## MEMORANDUM

**Subject:** Yarrow Bay Marina/Marina Suites LLC  
SHR06-00001, ZON06-00001, and APL06-00010

Marina Suites LLC is proposing to extend a pier and redevelop the upland portion of the Yarrow Bay marina site located at 5207 Lake Washington Blvd NE (see Enclosure 1). The applicant is requesting approval for the following (see Enclosure 2):

Landscape Plan

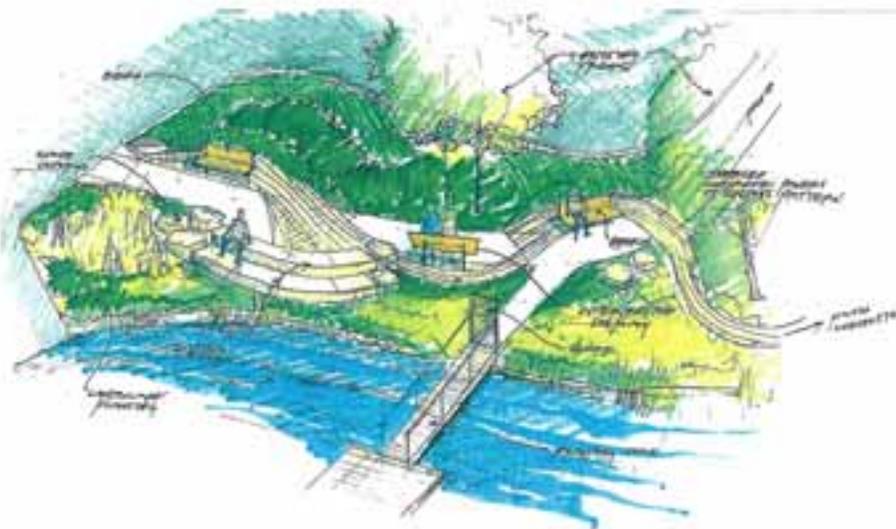
- (g) The applicant has submitted a landscape plan (see Sheets L-2 and L-3 of Attachment 2.a) that provides information on the proposed landscaping, including proposed placement and species of plant materials, as well as the mature height of proposed species. Within the view corridor, the applicant has proposed to install a variety of shrub species and has indicated that the shrubs to be installed would have a maximum mature height of 36 inches. According to the information in *Sunset Western Garden Book*, some of the species (e.g. *Berberis thunbergii* 'gentry', Otto Luyken Laurel, etc.) would require sheering or pruning to maintain the mature height of 36 inches.

- (d) Some of the proposed shrubs would exceed the maximum allowed mature height of three feet above average grade. As a result, the planting plan should either be revised to include only those shrubs that would not exceed 3 feet above finished grade or the applicant should submit a perpetual maintenance agreement, to be recorded with King County, to maintain the vegetation within the view corridor to a height no greater than three feet above finished grade.

- (e) The vegetation along the south property line is located within the view corridor and therefore is subject to the height limit of three feet above average grade. However, due to the grade change across the property and the existing intrusions into the view corridor by the several trees, there are opportunities to permit vegetation that would be taller than 3 feet above finished grade and still not further obscure the view from Lake Washington Boulevard to and beyond Lake Washington. As a result, staff recommends that the vegetation along the south property line buffering the driveway be permitted to exceed three feet above finished grade. To insure that the views are not further impacted, staff recommends that the applicant submit a site section through the landscape buffer demonstrating that the landscaping (at mature height) would not project into the line of sight from Lake Washington Boulevard to the high water line.

3. Condition 2.d(2) shall be revised as follows: ~~Within the view corridor, except along the buffering for the access driveway, the plans shall either be revised to include only those shrubs that would not exceed 3 feet above finished grade or~~ The applicant shall submit a perpetual maintenance agreement, to be recorded with King County, to maintain the vegetation within the view corridor to a height no greater than three feet above finished grade.

- d. Final landscape plans, in compliance with the following requirements:
    - (1) Within the view corridor, except along the buffering for the access driveway, the plans shall either be revised to include only those shrubs that would not exceed 3 feet above finished grade or the applicant shall submit a perpetual maintenance agreement, to be recorded with King County, to maintain the vegetation within the view corridor to a height no greater than three feet above finished grade (see Conclusion II.G.1.a(2)(d)).

- (2) The plans shall provide the 5-foot wide buffer for the driveway required under KZC 95.40.7.b (see Conclusion II.G.3.b(2)). The applicant shall submit a site section through the landscape strip demonstrating that the landscaping (at mature height) would not project into the line of sight from Lake Washington Boulevard to the high water line (see Conclusion II.G.1.a(2)(e)).

TREE PLAN

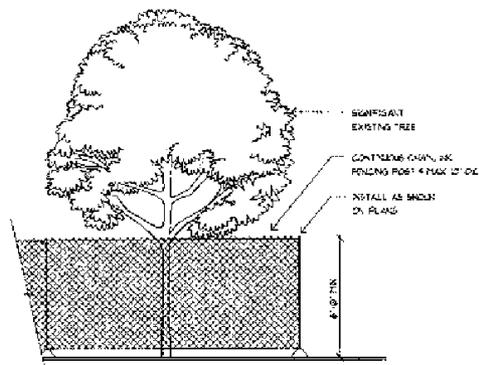
- (6) Vegetation:
- (a) Pursuant to requirements of KZC 95.35.2.b)2), the applicant is required to submit a Tree Plan II. To fulfill this requirement, the applicant has submitted a tree plan (see Sheet L-1 of Attachment 2.a) and the results of an arborist report completed by Greenforest, Inc. (see Enclosure 10 of Attachment 5). A tree survey completed as part of this report identified 19 trees on the Marina property or abutting right-of-way. The arborist provided an assessment of the viability and health of these trees, together with 40 trees located on the adjacent properties to the north and south whose canopy overhang onto the site. The arborist also established the location of limits of disturbance around all of the trees.

- (c) On the tree plan, the applicant has indicated which trees are proposed for retention and removal. Tree #152 has been proposed for removal and work is proposed within the limits of disturbance as established by the arborist, associated with the retaining wall to be installed offset from the south property line to retain the fill needed to raise the elevation of the access roadway.

- b. A copy of the approved Tree Plan II (see Conclusion II.A.1.b(3)).
  - c. A report from a certified arborist providing special instructions for work within the limits of disturbance of those trees shown to be retained along the waterfront area (see Conclusion II.A.1.b(4)). The recommendations shall be incorporated into the plan sets.

# PROPOSED YARROW BAY MARINA FUELING PLAN VIEW

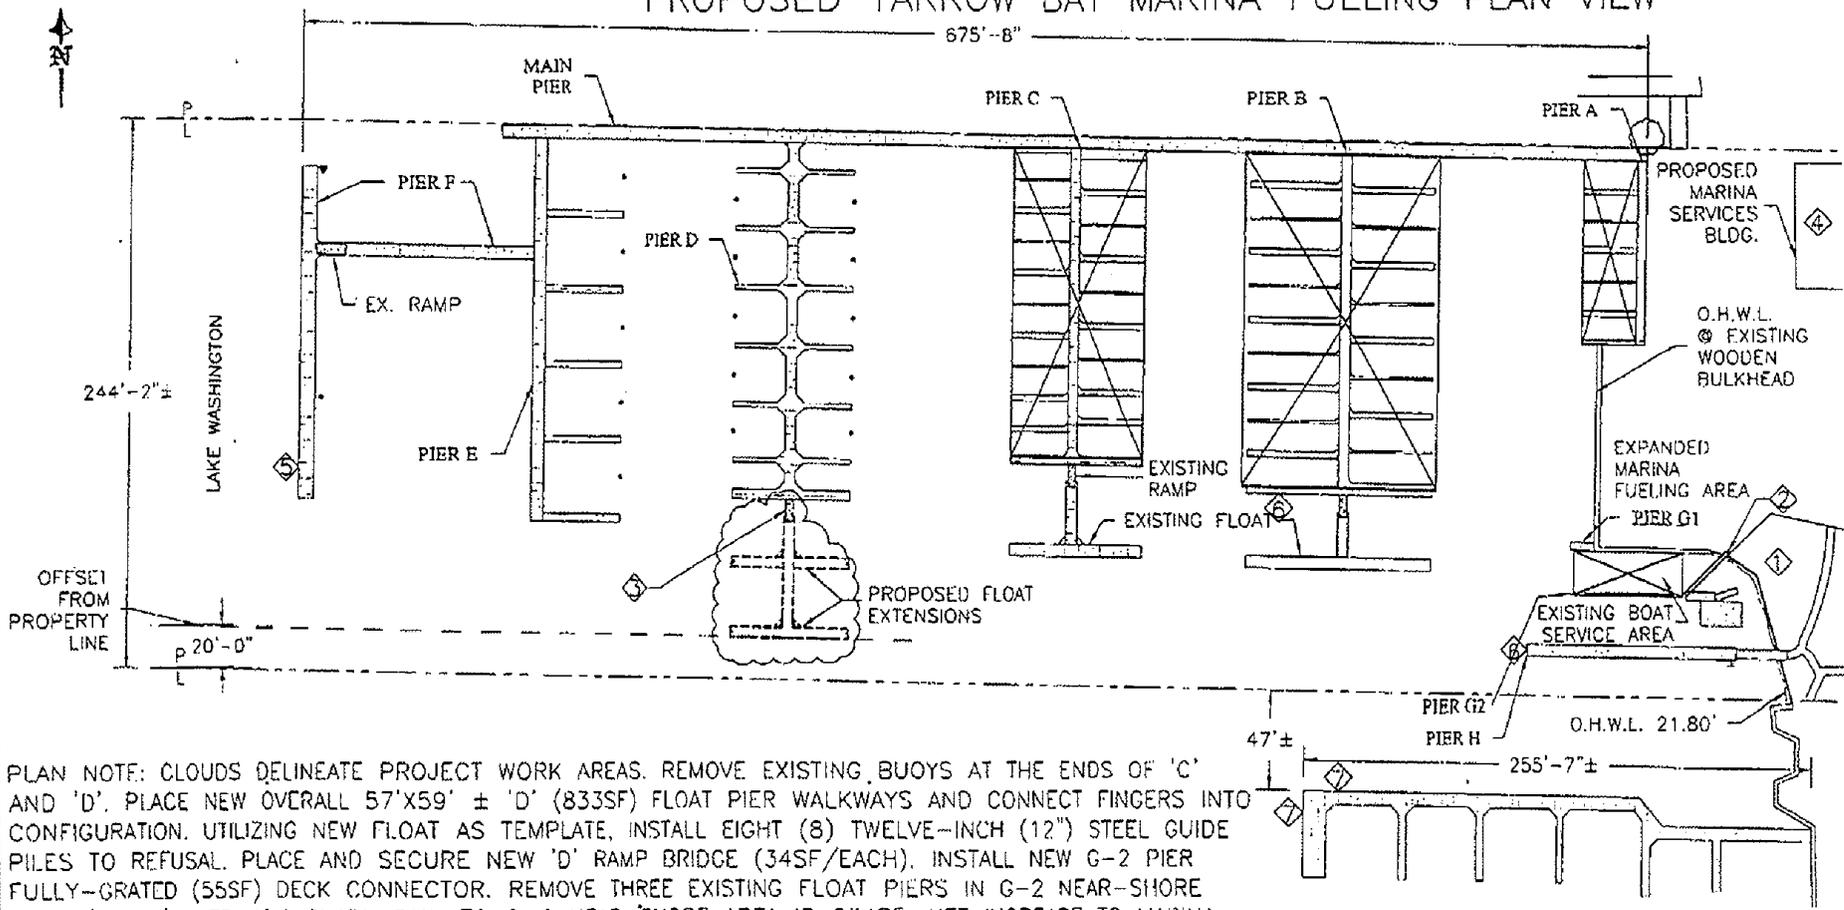
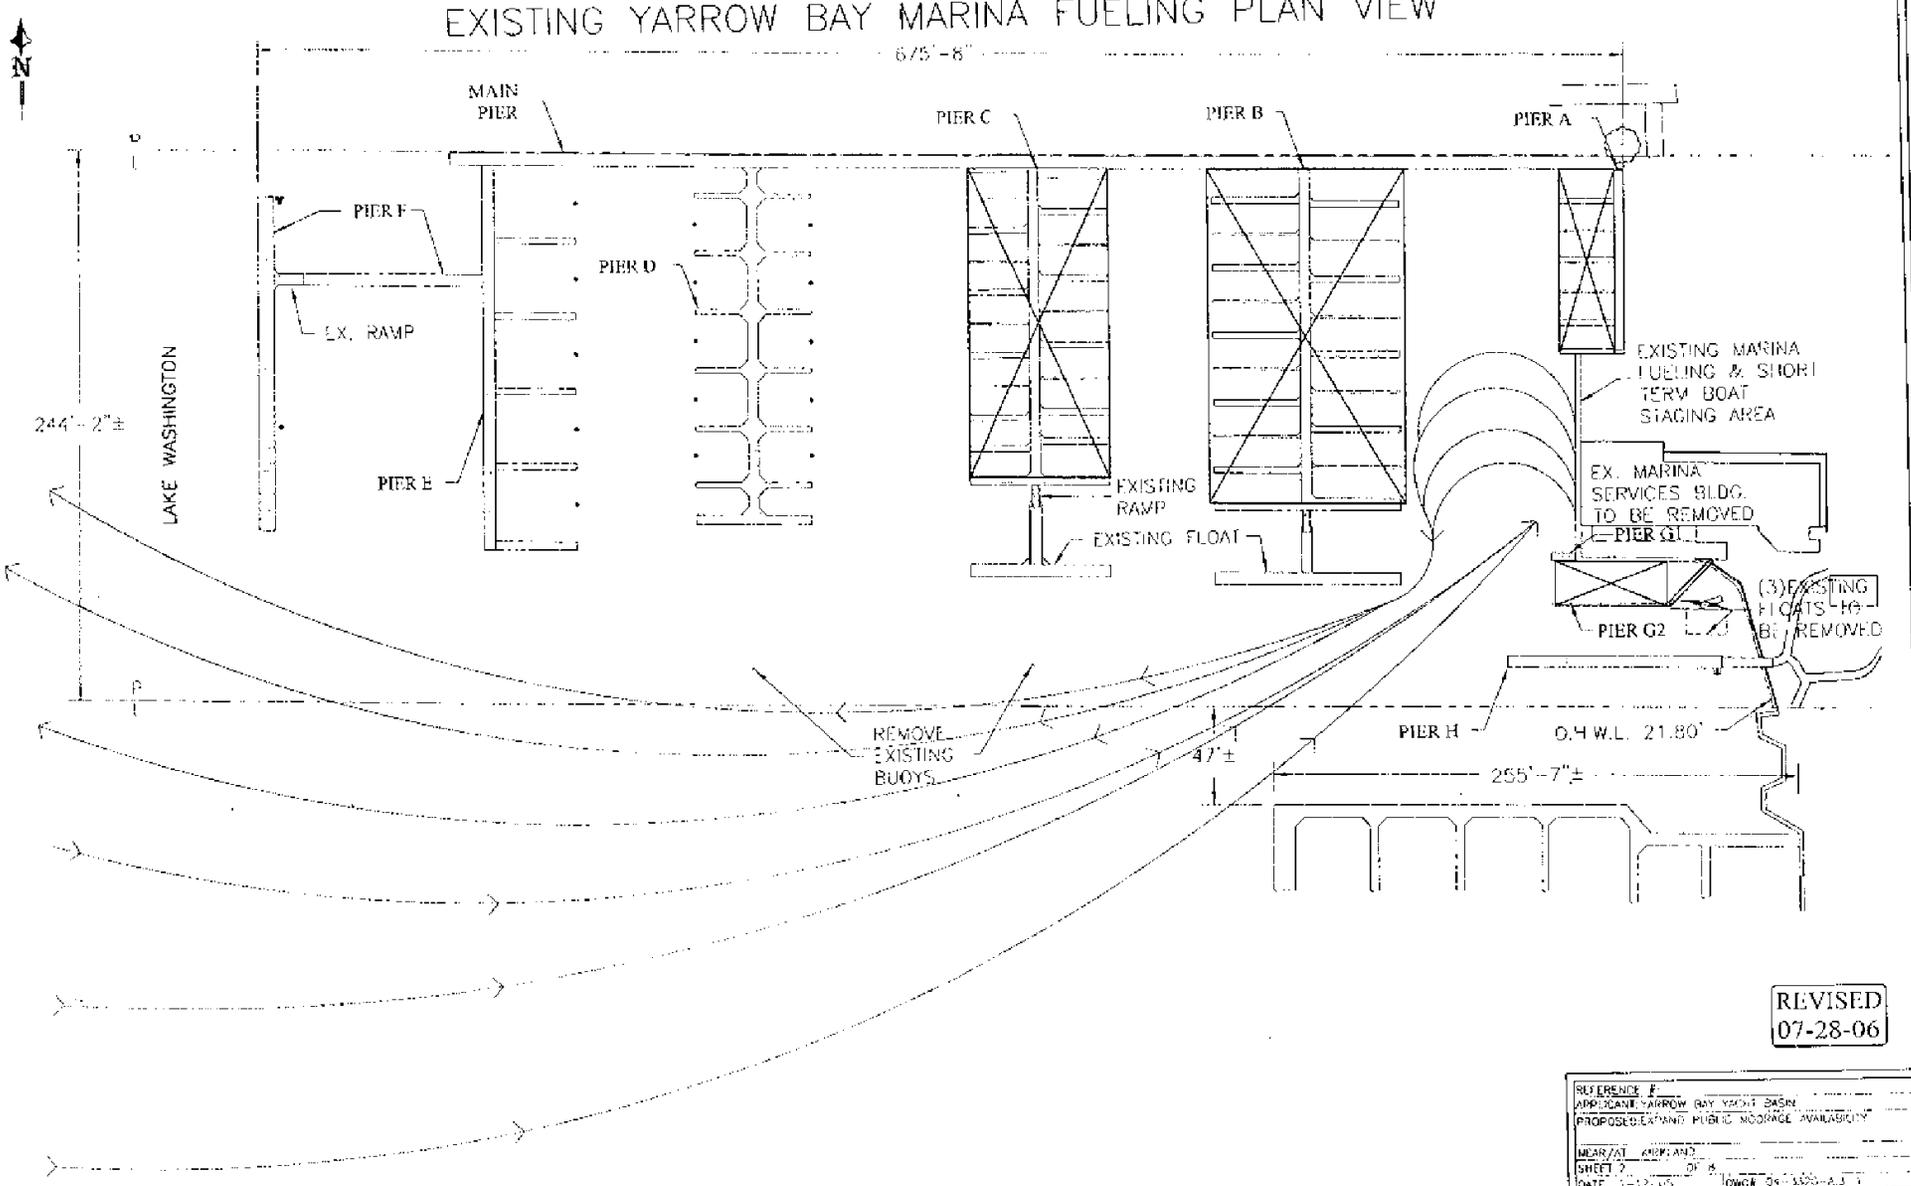
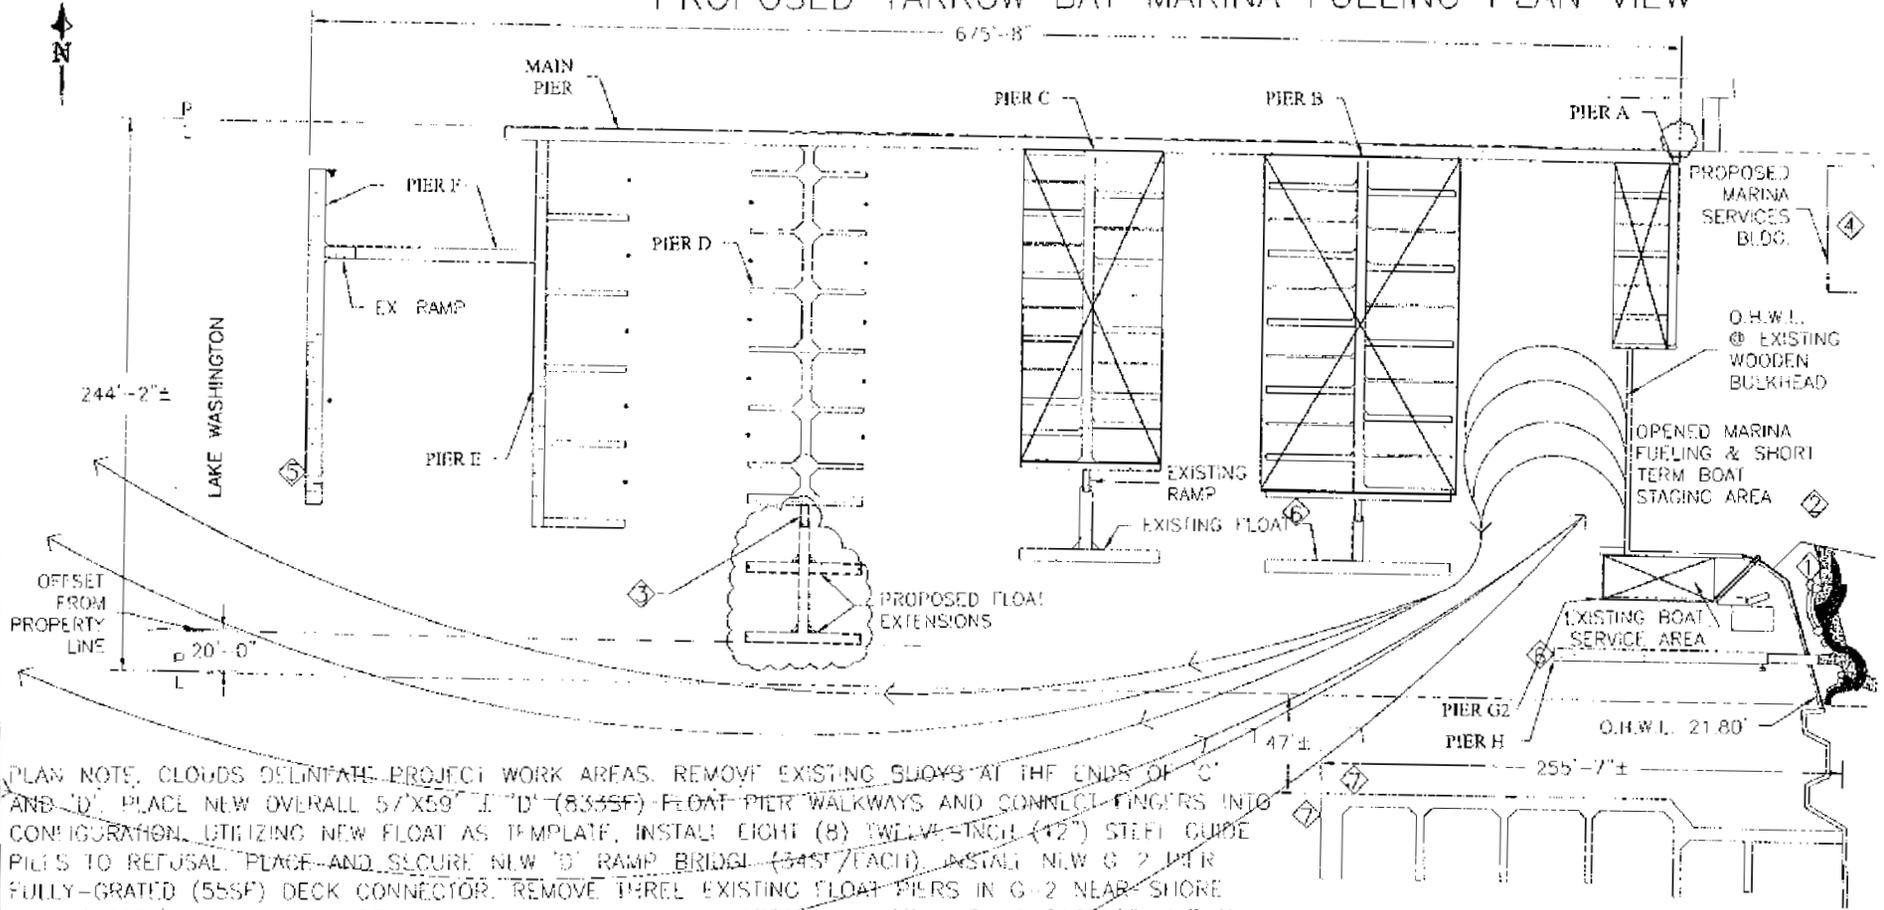
*Staff is not aware of any restrictions on use of public waters that would preclude access across the waters in front of the Breakwater Condominiums. The applicant has submitted a plan that shows the existing and anticipated boat access to the fueling facility (see Attachment 10). Access across the public waters in front of the Breakwater site to reach the marina facilities, including the fueling facilities, would continue, but the separation between the proposed float pier addition and the Breakwater Condominium dock is sufficient to insure that boats can maneuver around the edge of the moorage facility without further impact to the use and enjoyment of the Breakwater Condominium dock. The applicant has also submitted a proposal (see Attachment 11) to include wayfinding and warning signage for customers advising them not to tie up to the private pier of the Breakwater Condominiums. The applicant would need to obtain permission from the residents of the Breakwater Condominiums before placing any signage on their property.*

The Zoning Code establishes a 10 foot minimum setback from the south property line with which the proposed pier extension would comply. In addition, the applicant has submitted a plan that shows the existing and anticipated boat access to the fueling facility (see Attachment 10). Access across the public waters in front of the Breakwater site to reach the marina facilities, including the fueling facilities, would continue, but the separation between the proposed float pier addition and the Breakwater Condominium dock is sufficient to insure that boats can maneuver around the edge of the moorage facility without further impact to the use and enjoyment of the Breakwater Condominium dock. The applicant has also submitted a proposal (see Attachment 11) to include wayfinding and warning signage for customers advising them not to tie up to the private pier of the Breakwater Condominiums.

3. Moorage is not permitted on the outside of the floating pier addition (see Conclusion II.G.5.b(10) and II.H.2.d).
4. As part of the application for a Building Permit for the floating pier addition, the applicant shall submit plans consistent with the following standards:

- b. The plans shall include the location and design of signage posted to prohibit moorage on the outside of the proposed floating pier addition (see Conclusion II.G.5.b(10) and II.H.2.d).
